ENGINEERING CHANGE NOTICE

Proj. ECN W-105-213

5. Project Title/No./Work Order No.	6. Bldg./Sys./Fac. No.	7. Impact Level
LERF, 242-A EVAP INTERIM RETENTION BASINS, W-105	242-AL	3Q 3/SC3 DRS 10-20-92

LOI #115 DIRECTS KEH TO REMOVE VALVE & ACTUATOR MOV 43-1, ALSO LOI #119 DIRECTS KEH TO INSTALL REDUCED CAPACITY LEACHATE PUMPS AND FLOW INSTRUMENTATION.

DETAIL 1
SCALE: NONE

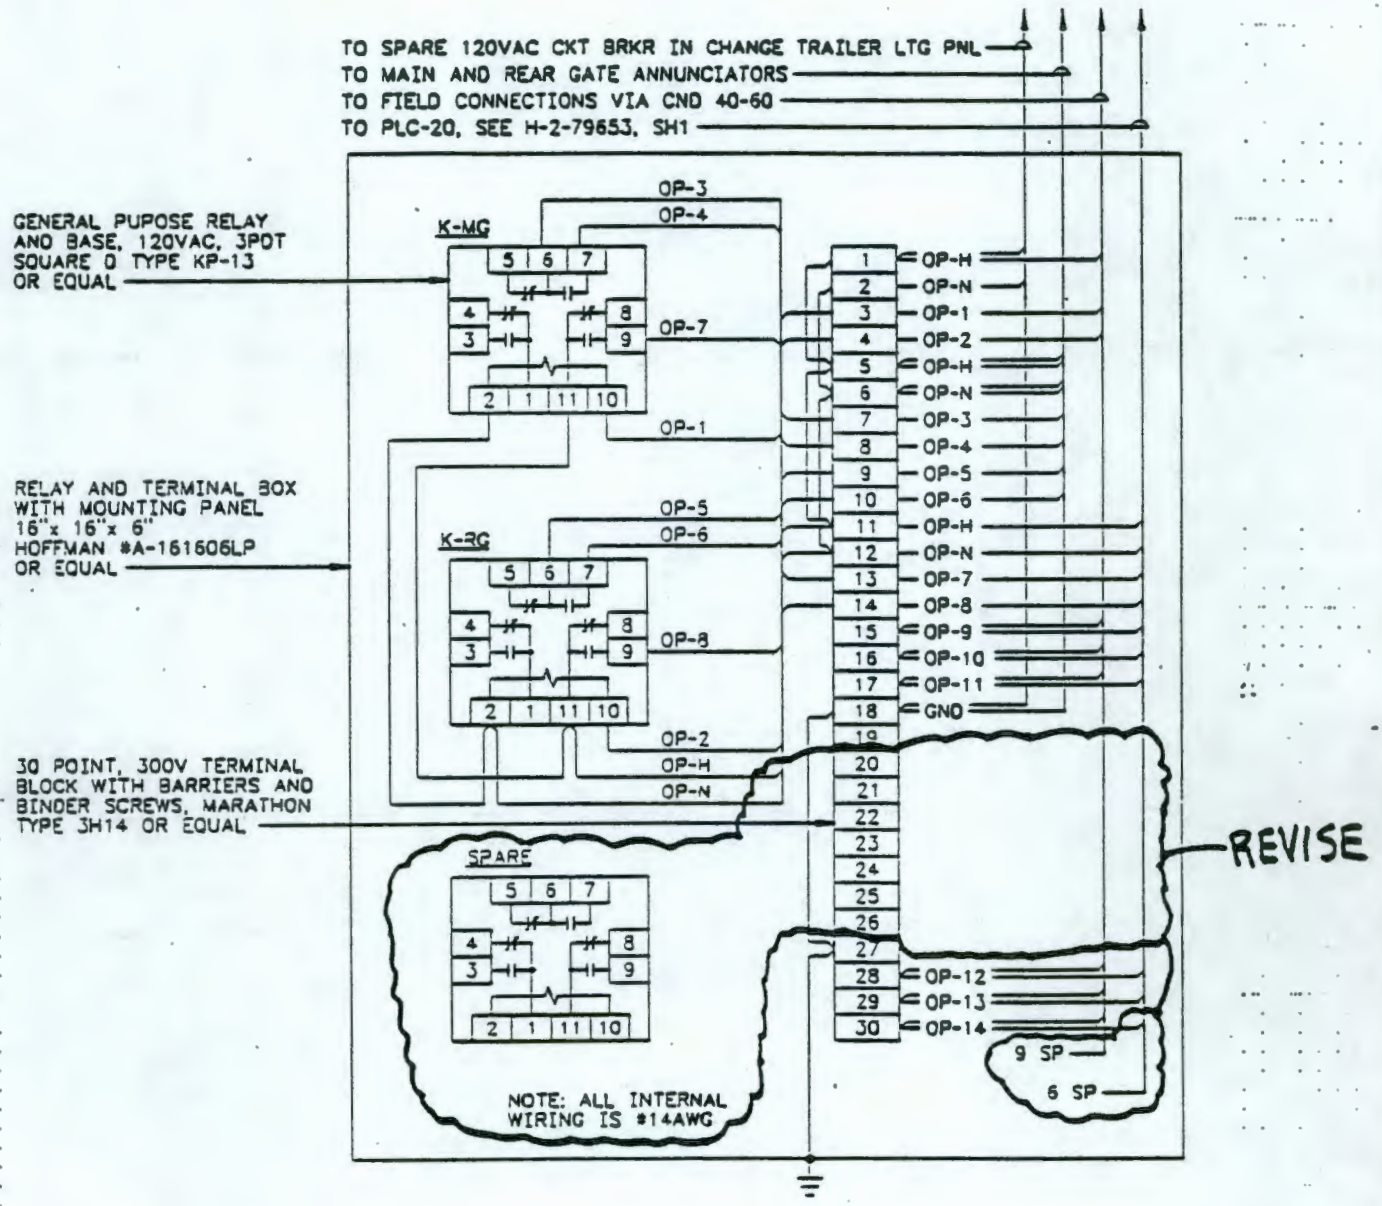
- REVISE DETAIL 1 AS SHOWN ON PAGE 4.

ENLARGED PLAN
CATCH BASIN 242AL-42
SCALE: 1/4" = 1'-0"
SEE Z E-6

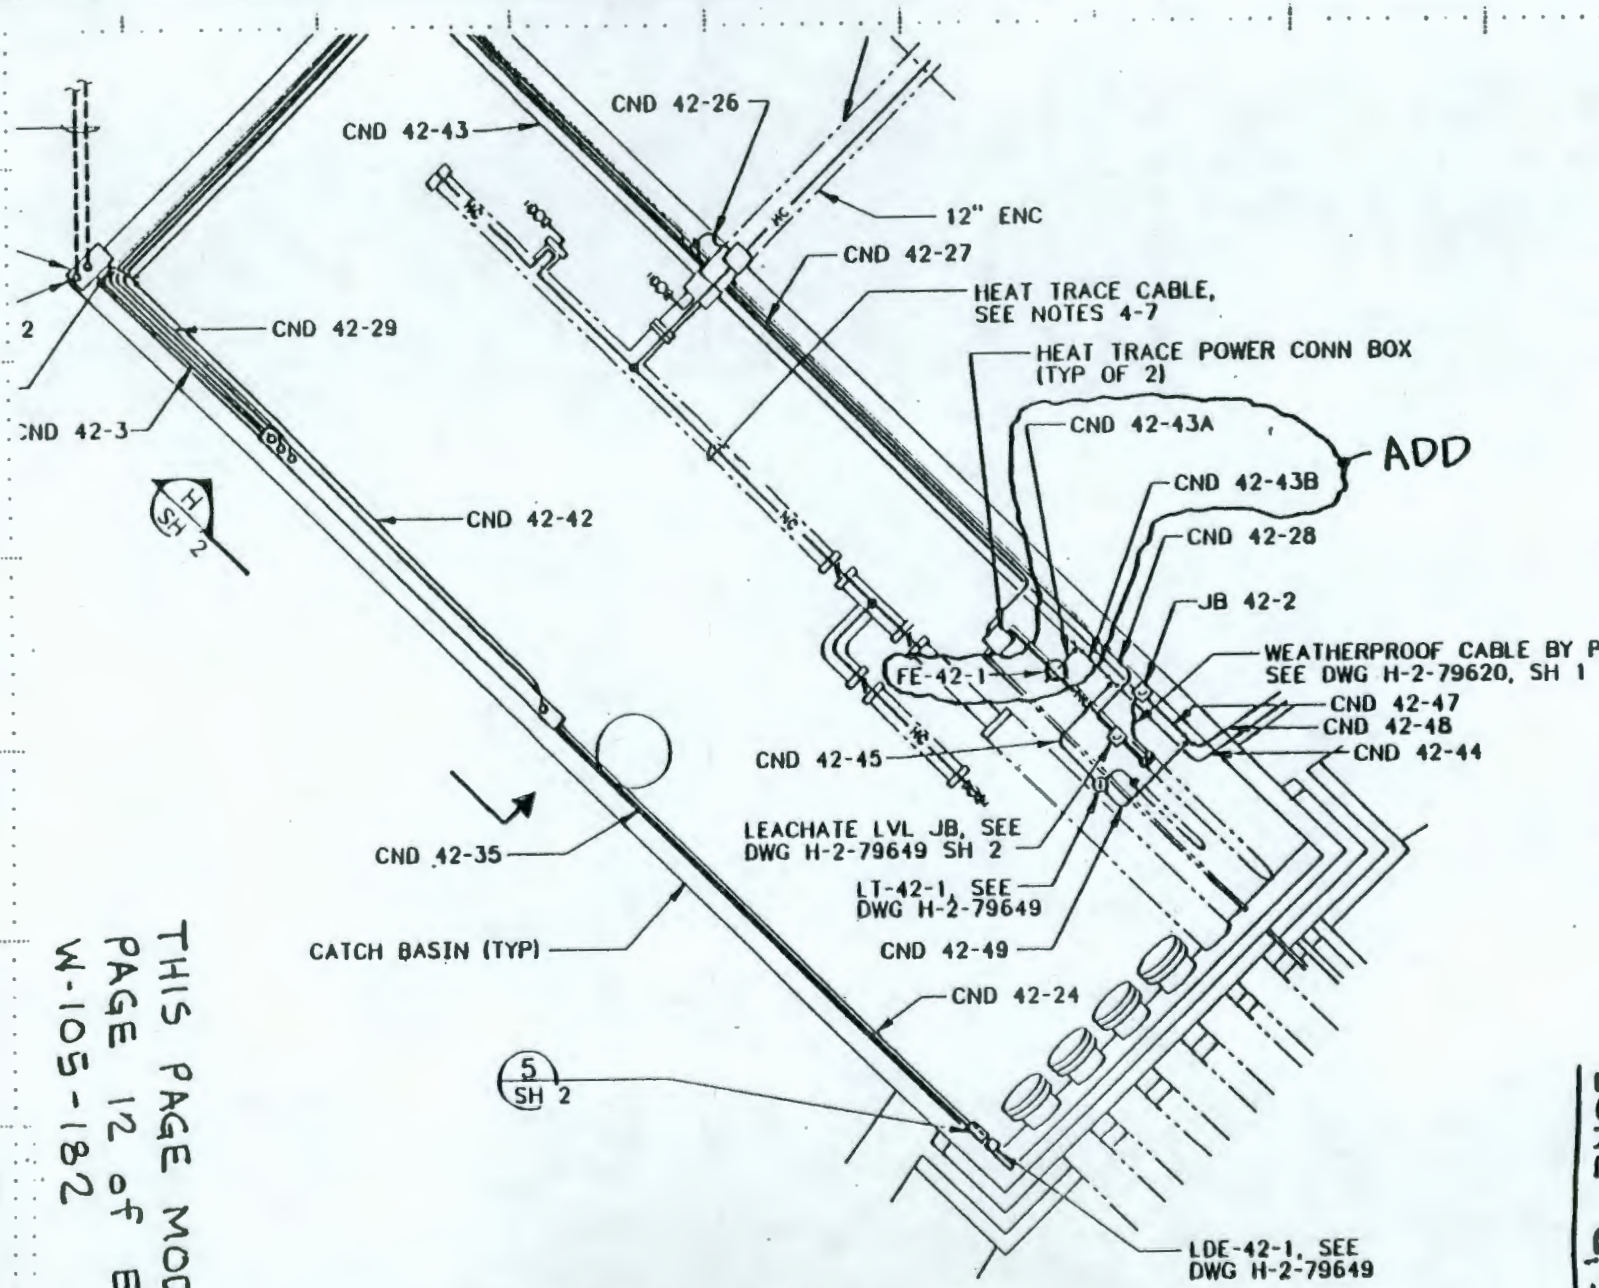
- ADD FE-42-1 AND ADDITIONAL CND AS SHOWN ON PAGE 5.

ENLARGED PLAN
CATCH BASIN 242AL-43
SCALE: NONE
SEE SH 1, Z E-5

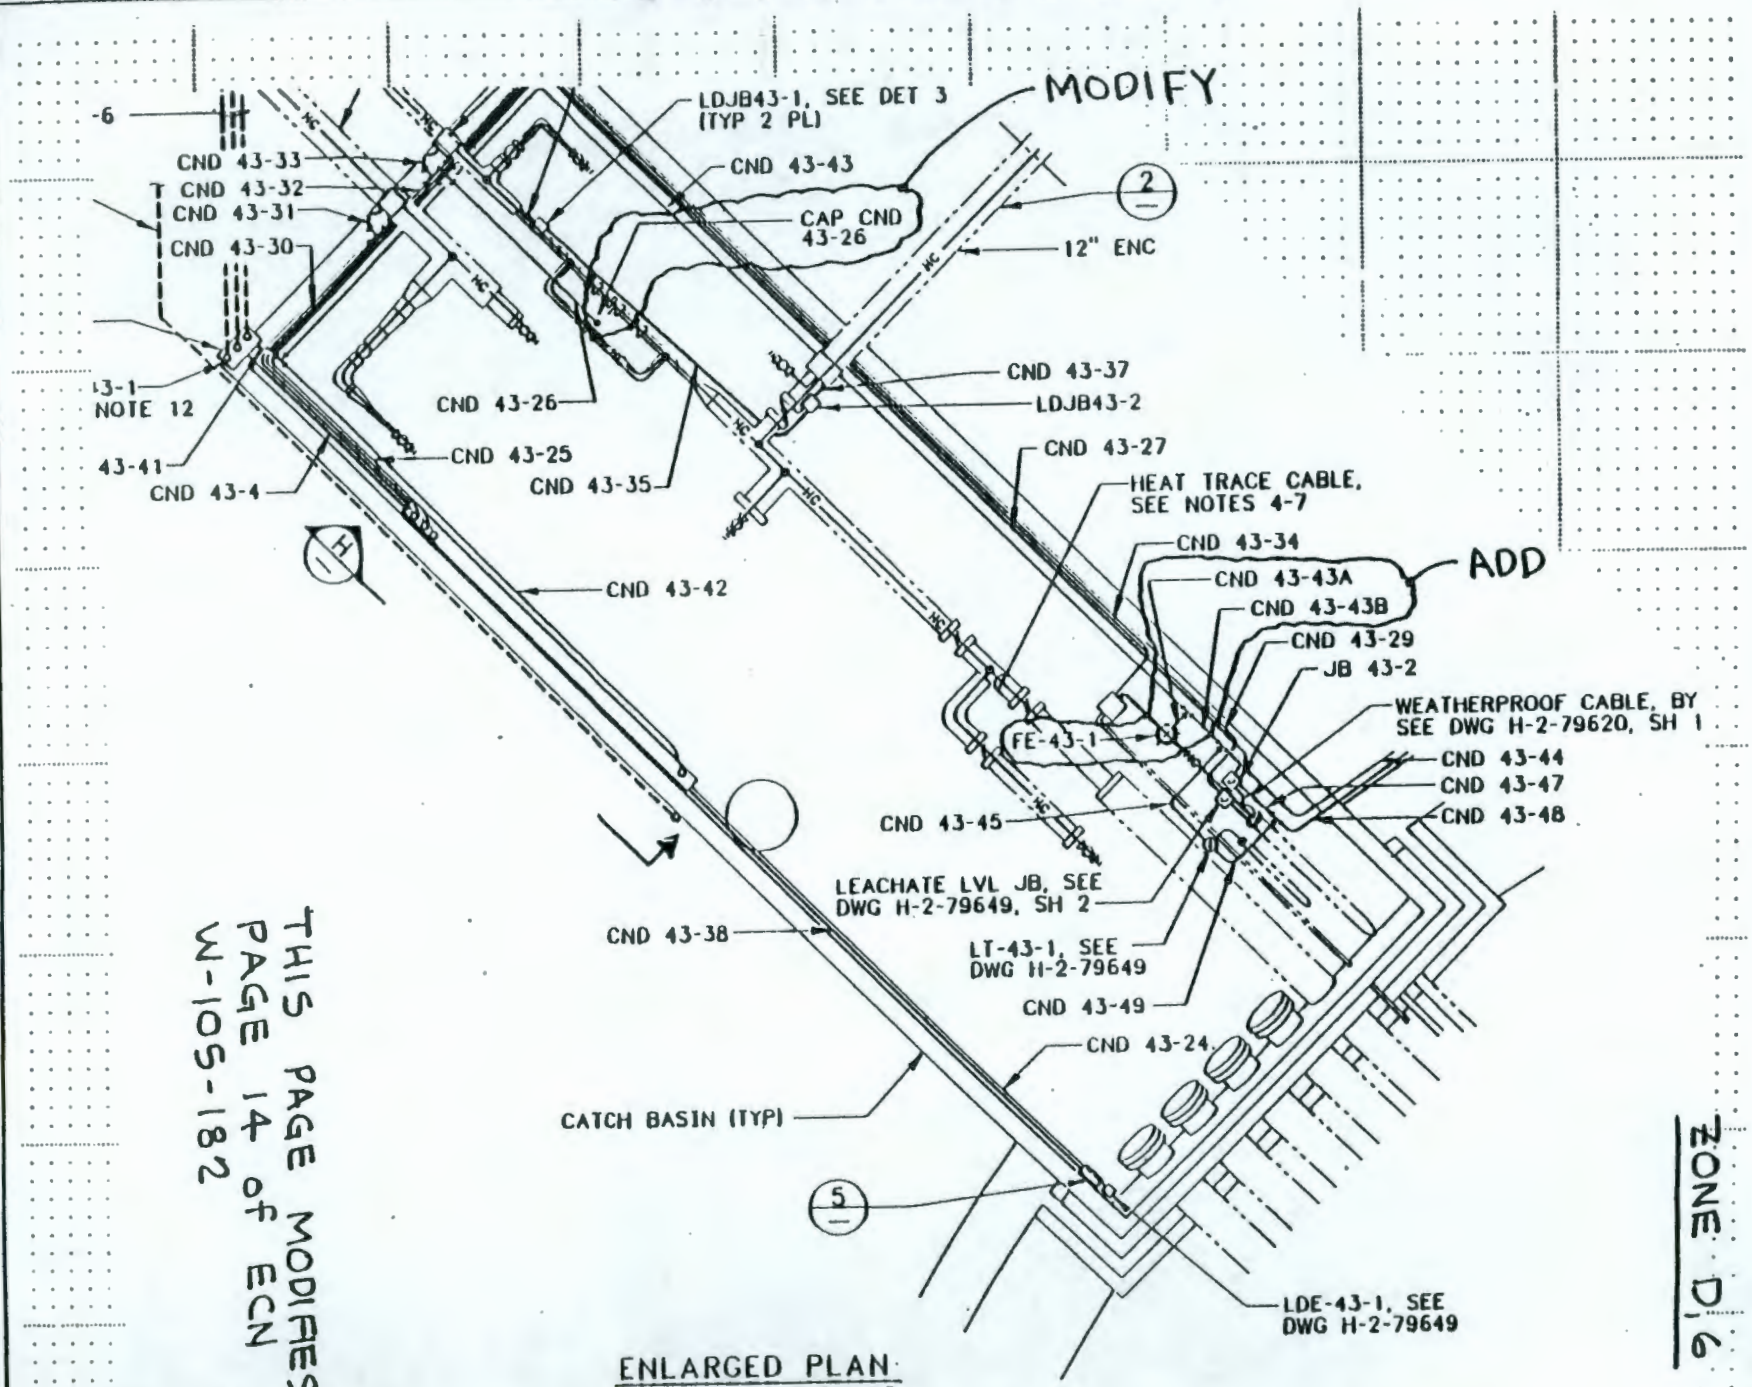
- ADD FE-43-1 AND ADDITIONAL CND AS SHOWN ON PAGE 6.
- ADD FE-44-1 AND ADDITIONAL CND AS SHOWN ON PAGE 7.
- REVISE NAMEPLATE LEGEND AS SHOWN ON PAGE 7.
- REVISE ELEV "H" AS SHOWN ON PAGE 8.

ENLARGED PLAN
CATCH BASIN 242AL-44
SCALE: NONE
SEE SH 1, Z E-3

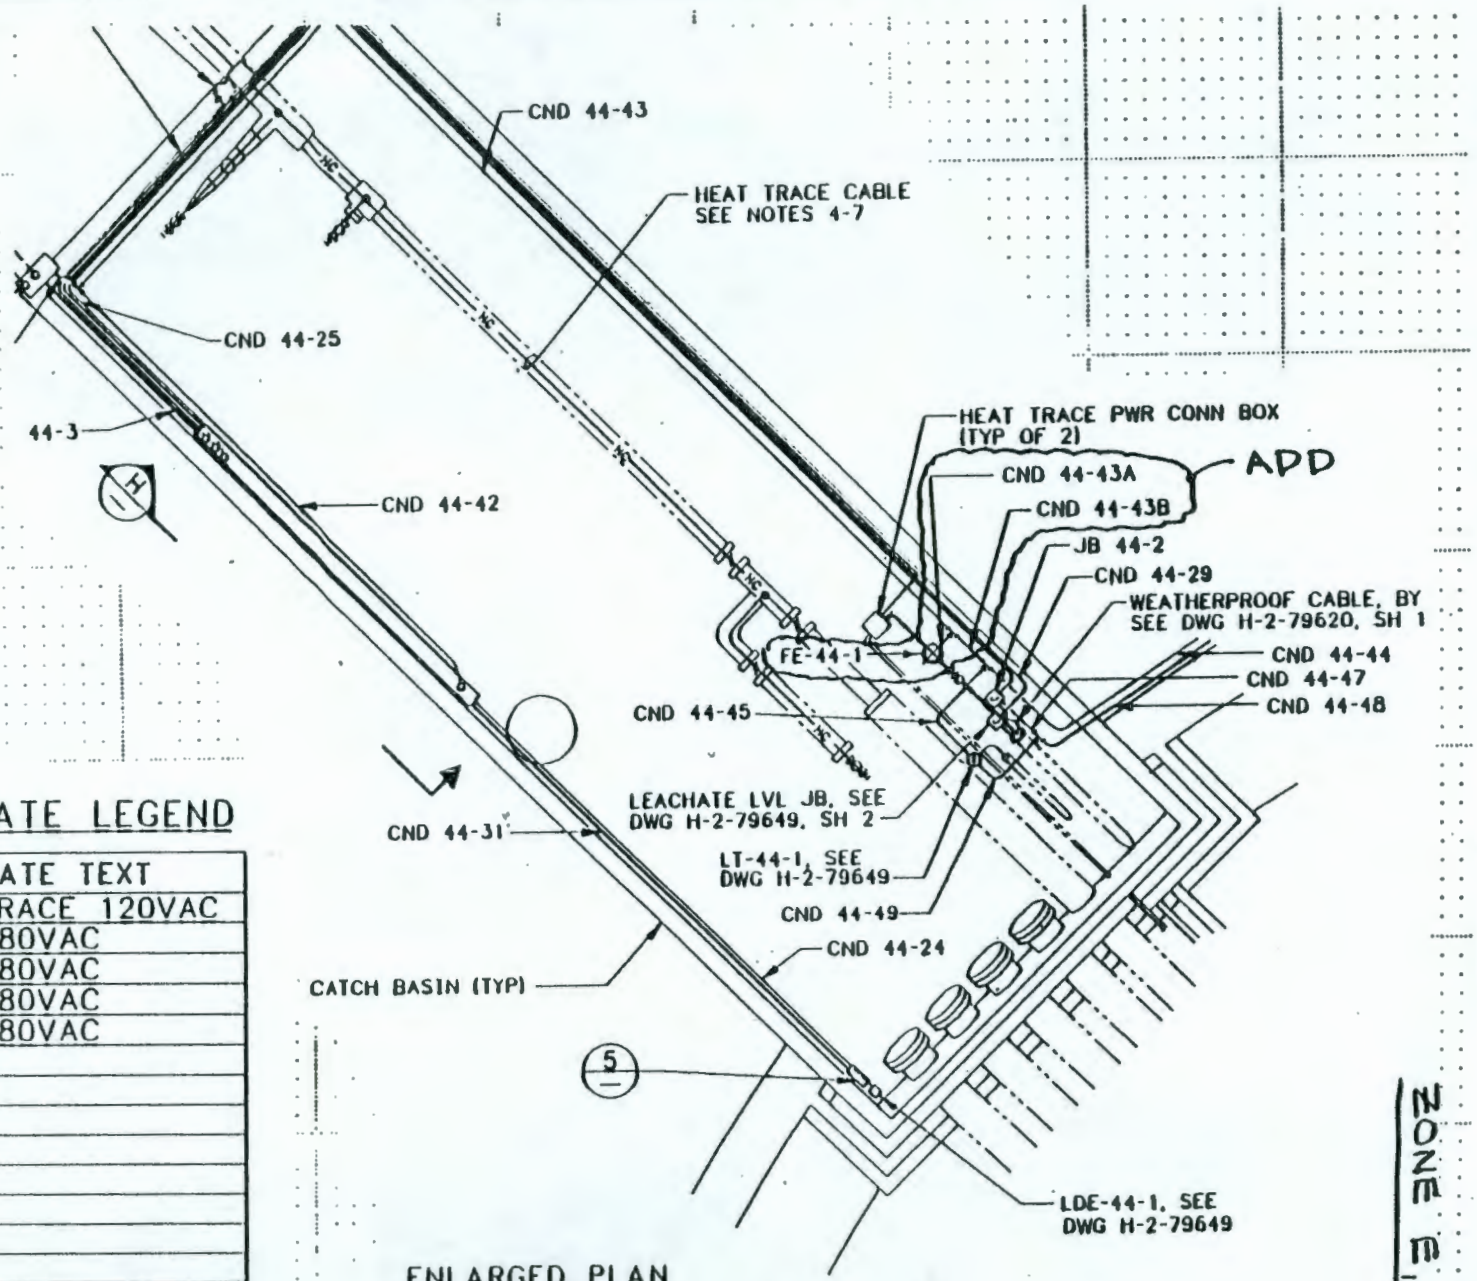
ADD

KAISER ENGINEERS HANFORD	ENGINEERING CHANGE NOTICE SKETCH					
Ref. Dwg.	Sh.	Rev.	Prepared By	Checked By	ECN No.	Page
H-2-79668	5	0	G. KUBINSKI	10/6/92 M L Alexander	W-105-213	10/15

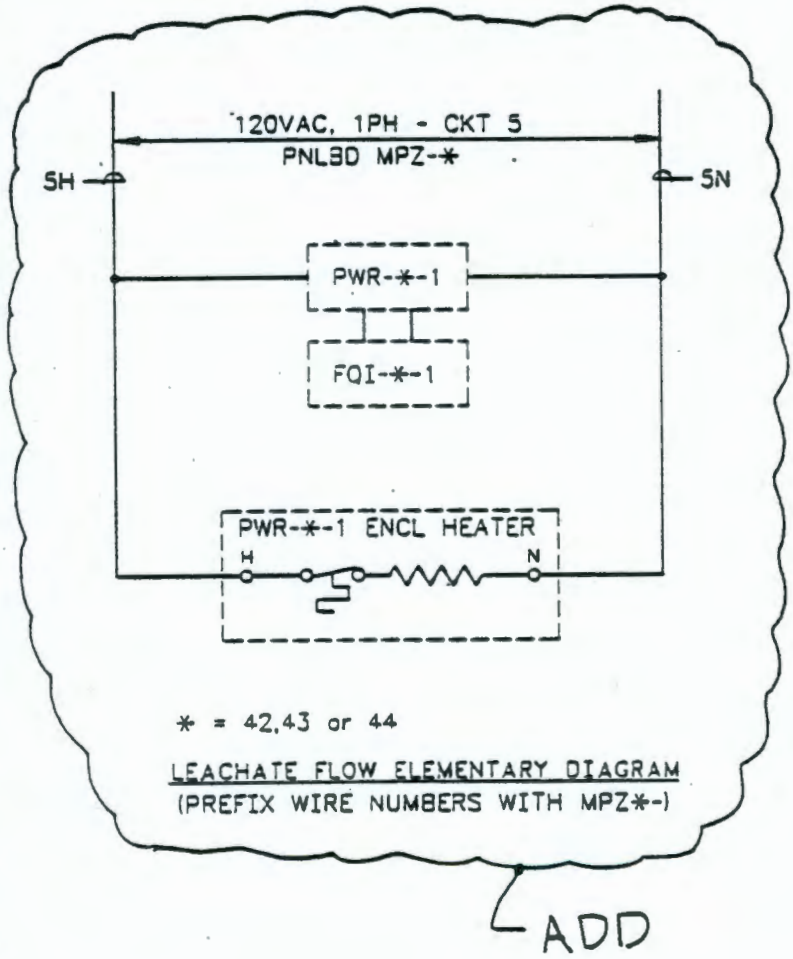
- REMOVE POWER FEEDER FOR MOV 43-1 AND ADD LEACHATE FLOW POWER SUPPLY FEEDER BREAKERS AS SHOWN ON PAGE 9.
- ADD PWR-*-1 & FQI-*-1 AND ENCLOSURE HEATER TO ELEMENTARY DIAGRAM AS SHOWN ON PAGE 10.
- DELETE MOV 43-1 ELEMENTARY DIAGRAM AS SHOWN ON PAGE 11.

ELEMENTARY DIAGRAM
MOV 43-1
(PREFIX WIRE NUMBERS WITH MPZ43-)

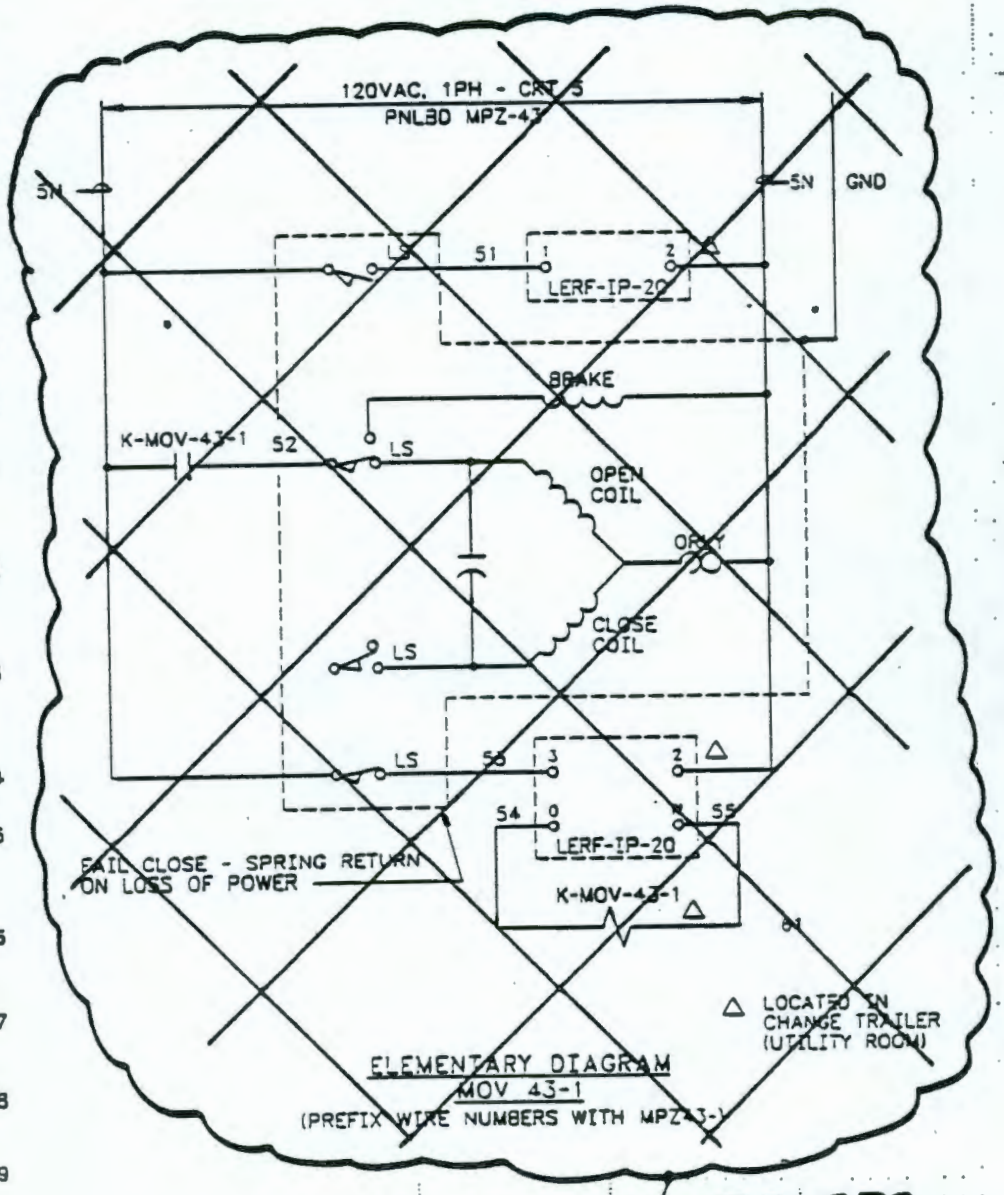
DELETE

NOTE: THIS PAGE VOIDS PAGE 30 of ECN W-105-116
